Appendix I of RNTPC
Paper No. A/NE-MKT/34B

**APPLICATION FOR PERMISSION
UNDER SECTION 16 OF
THE TOWN PLANNING ORDINANCE
(CAP. 131)**

(a) Proposed use(s)/development 擬議用途/發展	Proposed Temporary Warehouse for Storage of Construction Material for a Period of 3 Years and Filling of Land (Please illustrate the details of the proposal on a layout plan) (請用平面圖說明擬議詳情)

Application No. 申請編號	(For Official Use Only) (請勿填寫此欄)
Location/address 位置/地址	Lots 515 RP & 524 S.B in D.D.90, Lin Ma Hang Road, Ta Kwu Ling, N.T.
Site area 地盤面積	1,360 sq. m 平方米 ☒ About 約 (includes Government land of 包括政府土地 0 sq. m 平方米 ☐ About 約)
Plan 圖則	Approved Man Kam To Outline Zoning Plan No. S/NE-MKT/4
Zoning 地帶	'Agriculture' ('AGR')
Type of Application 申請類別	☒ Temporary Use/Development in Rural Areas for a Period of 位於鄉郊地區的臨時用途/發展為期 ☒ Year(s) 年 3 ☐ Month(s) 月 ☐ Renewal of Planning Approval for Temporary Use/Development in Rural Areas for a Period of 位於鄉郊地區臨時用途/發展的規劃許可續期為期 ☐ Year(s) 年 ☐ Month(s) 月
Applied use/ development 申請用途/發展	Proposed Temporary Warehouse for Storage of Construction Material for a Period of 3 Years and Filling of Land

Figure 4

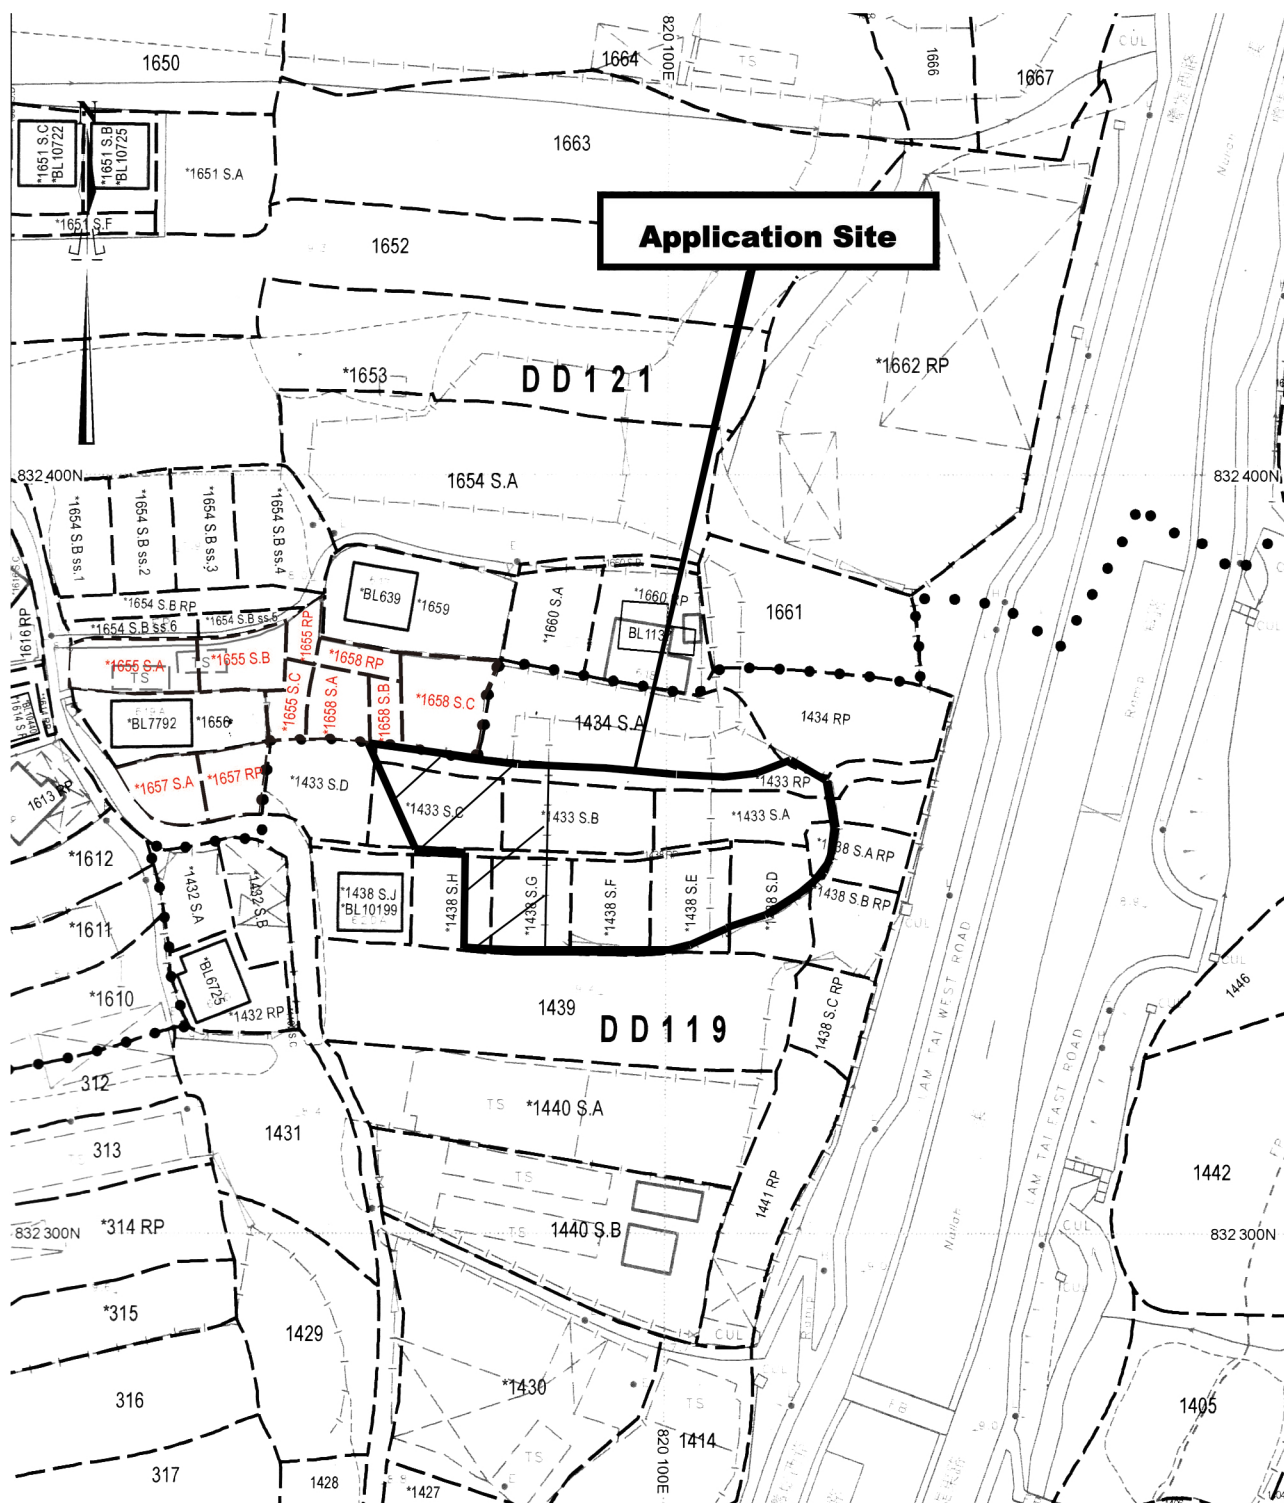
CE/MN, DSD's comments	Applicant's response
1. Photos should be submitted clearly showing the current conditions of the area around the site, the existing drainage/flowpaths around the site, the proposed drainage from the site to the downstream existing watercourse and the existing watercourse. The locations of the camera and the direction of each photo should also be indicated on a plan.	Noted. Please see photos in Annex 1 below. The photo viewpoint is shown in updated Figure 4.

Appendix A-Site Plan

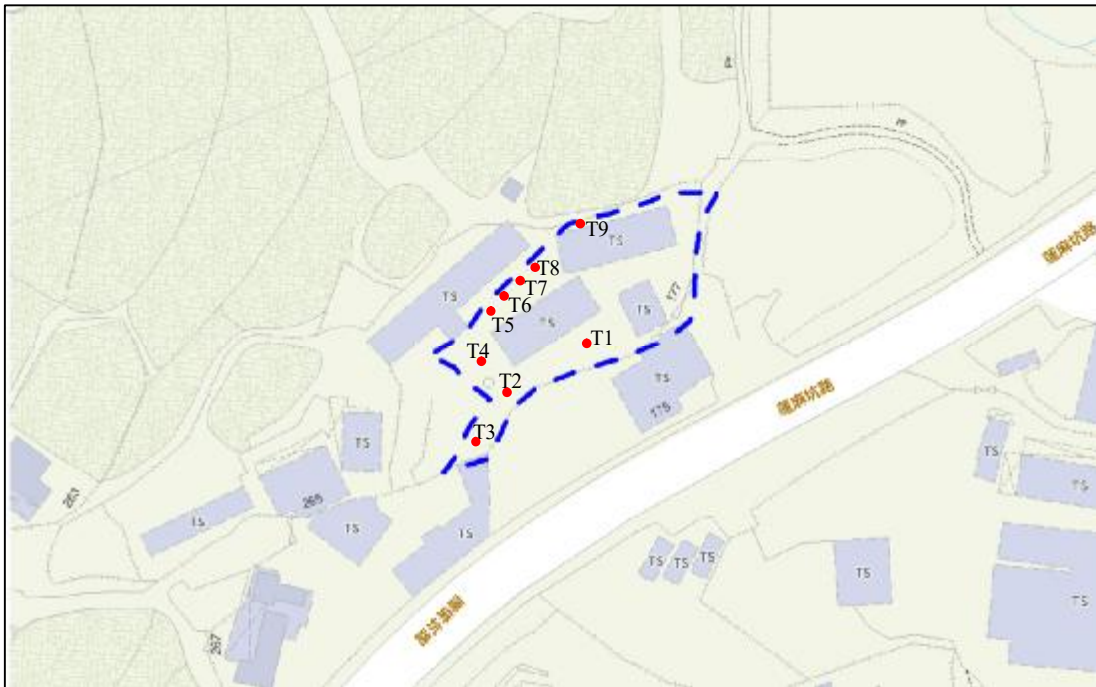
CTP/UD&L's comments	Applicant's response
2. Having reviewed the revised landscape proposal submitted by the applicant, 4 nos. of trees among the identified 11 nos. of trees are proposed to be retained and 7 nos. of trees are proposed to be felled. With reference to <i>Figure 2 – Proposed Layout Plan</i> of the submission, proposed warehouse is in conflict with the 4 nos. of trees (i.e. T5, T6, T7 and T8) proposed to be retained. As no landscape treatment/ mitigation measure is proposed, our previous comment item (4) dated 2.5.2024 remain valid. We maintain our concern that approval of the application may alter the landscape character and degrade the landscape quality of the surrounding area.	We wish to draw your attention that the greatest effort has been exhibited to retain the greatest number of trees possible and 4 trees (T5, T6, T7 & T8) are proposed to retain the updated tree survey report in the attachment. Also, a compensatory tree planting proposal is proposed for your consideration.

Figure 2

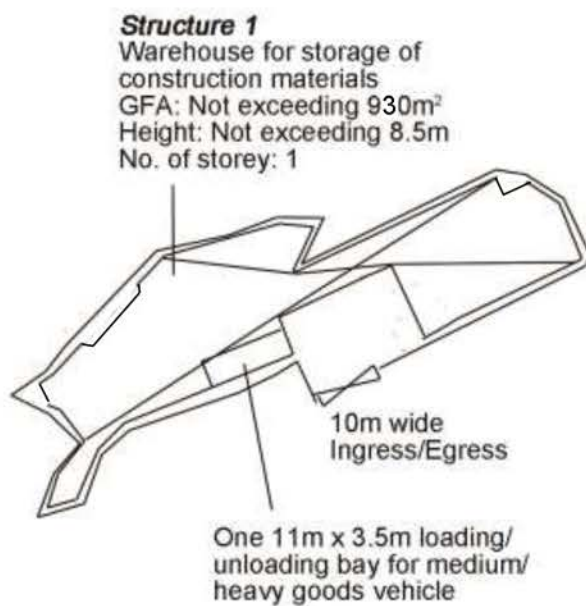
3. The applicant should provide revised layout plan with adjusted layout of the warehouse to maximize number of retained trees, and provide landscape treatment/ mitigation measure to mitigate the loss of the existing trees. The opportunity for tree planting to meet compensatory ratio of 1:1 in terms of number of trees felled/ aggregated DBH	Noted. Please see revised layout plan and updated page 2, 5 and 11 of the application form which shows the reduction in size (from 950m² to 930m²) of the proposed structure. Similarly, the applicant has updated the land filling area as shown in Figure 3 and the latest land filling area is reduced from 1,360m² to

Figure 15 Flow path at the downstream of the culvert

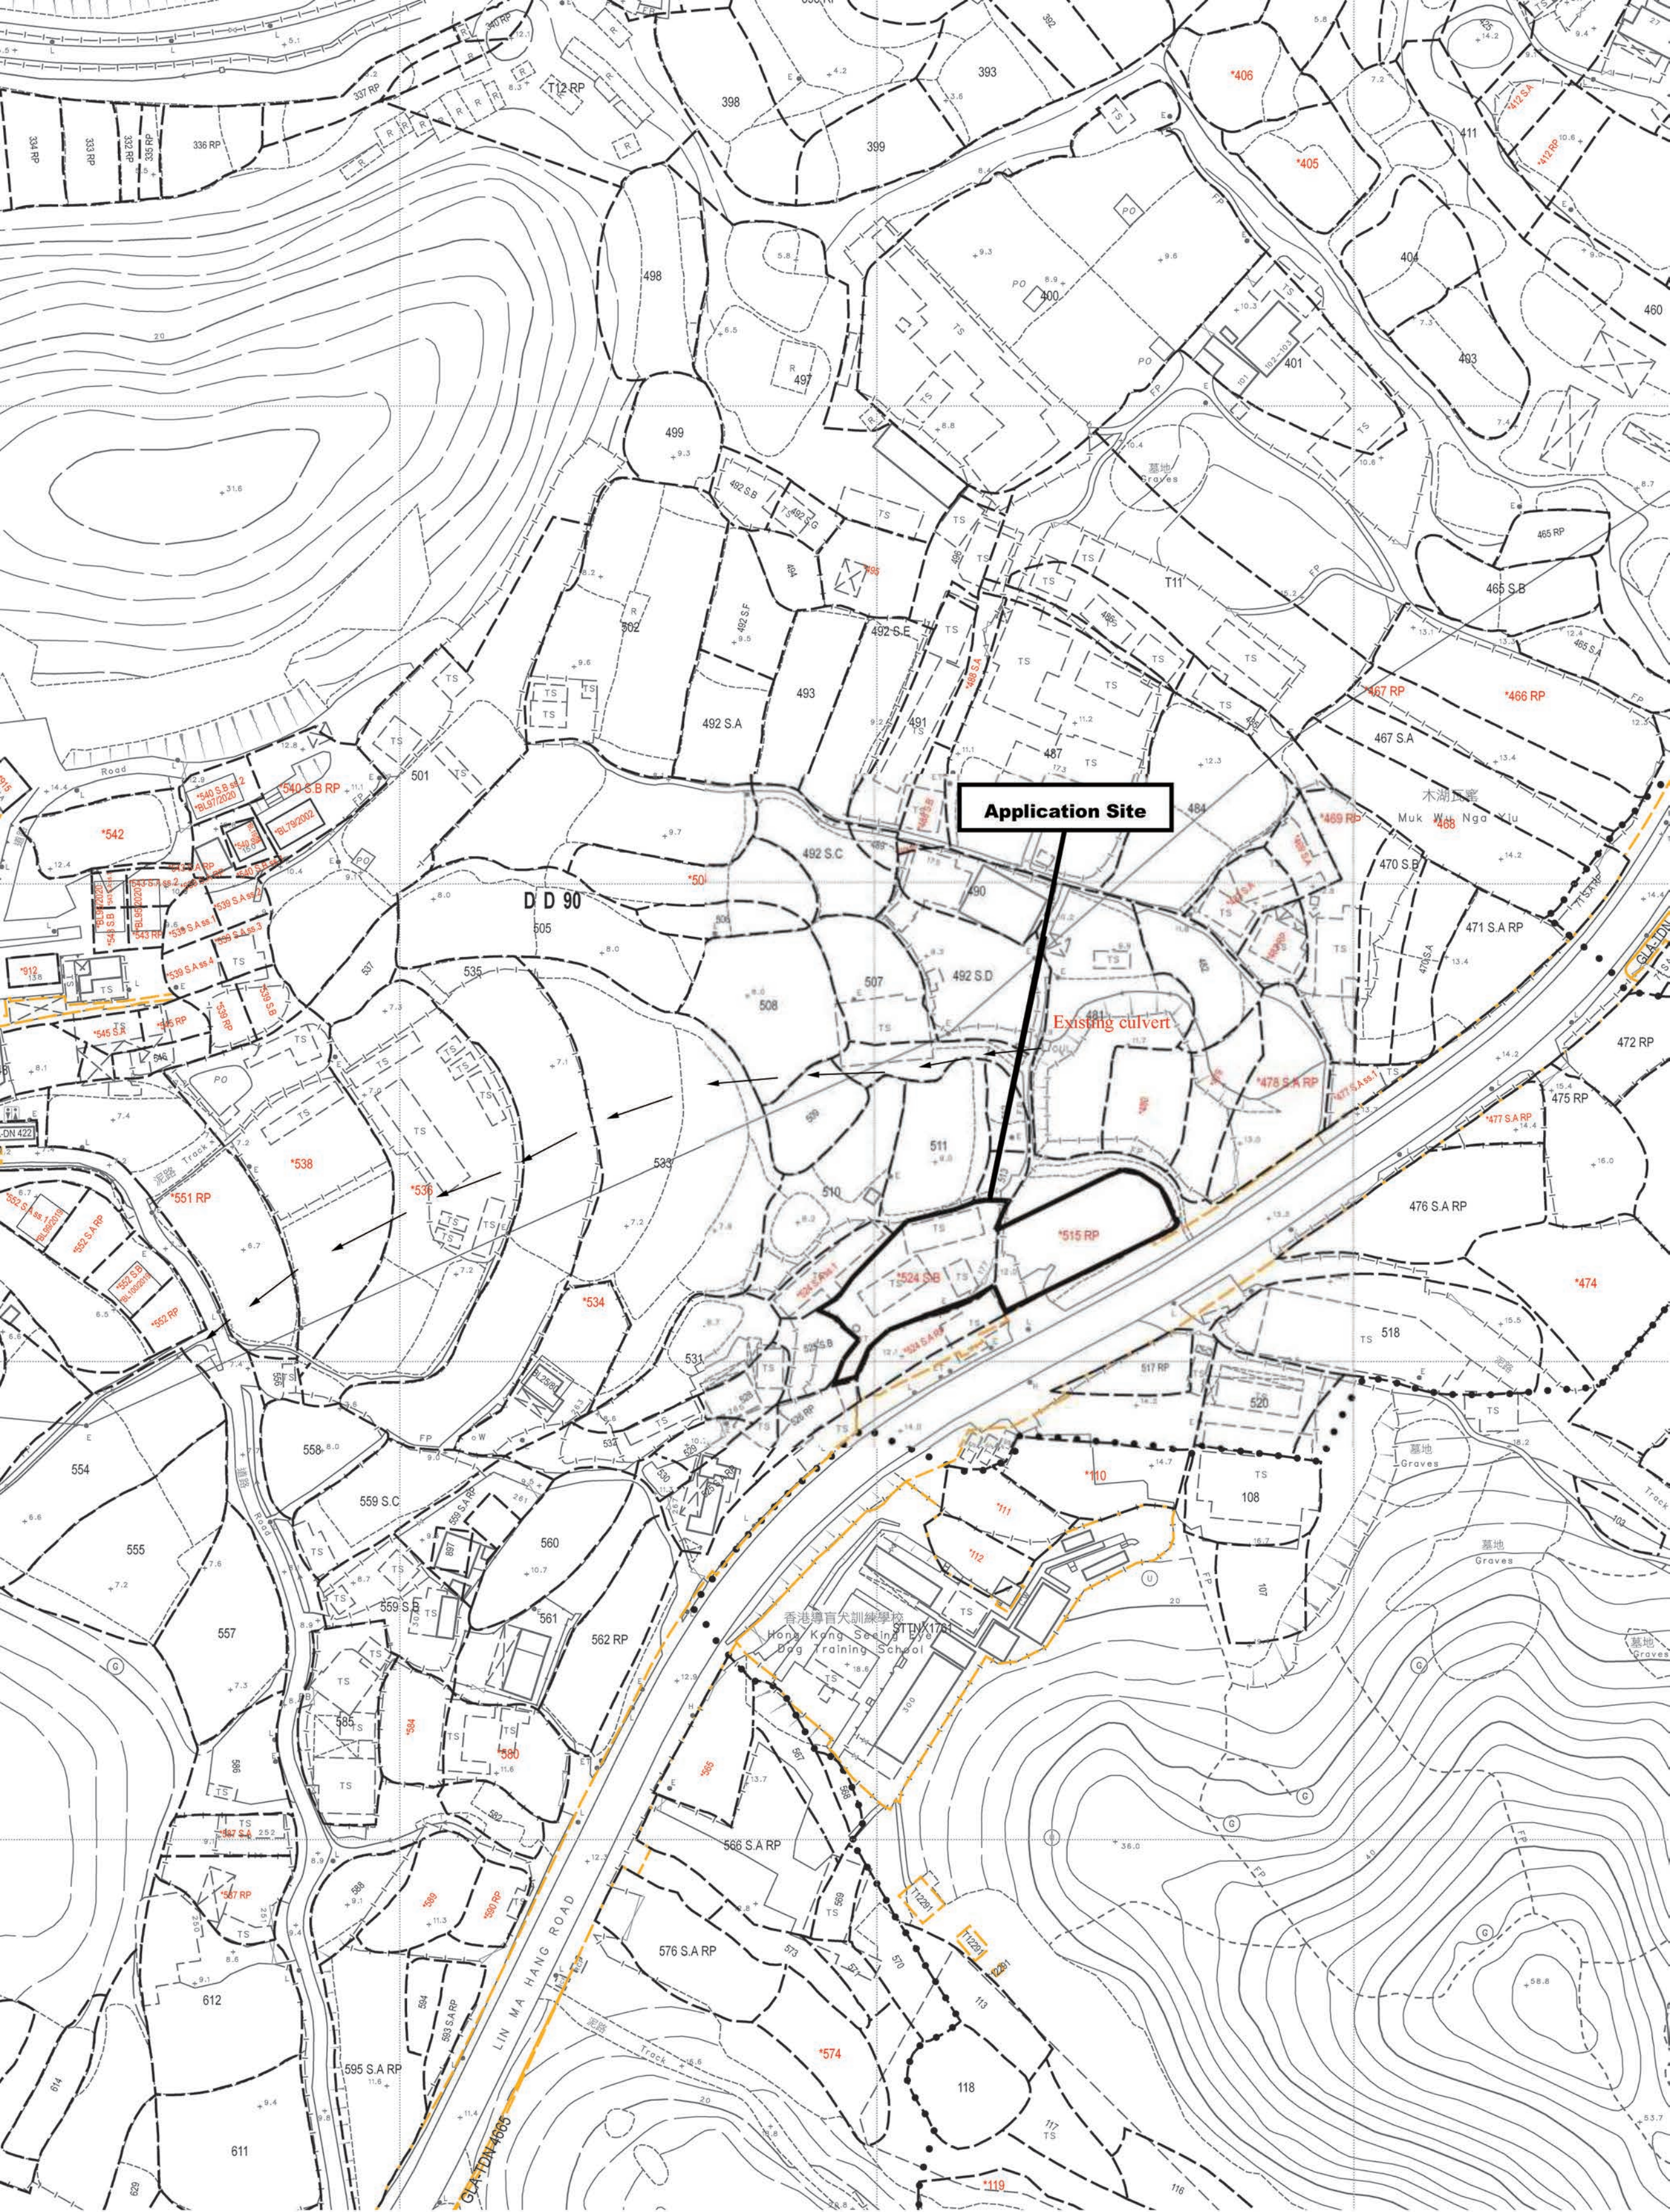
- having reviewed the drainage proposal submitted by the applicants, the alignment of the box culvert is outstanding from the submission. Also, there is no record of downstream watercourse as marked on Figure 15, the applicants are requested to further substantiate and clarify on the drainage downstream with plan and on-site photos; and
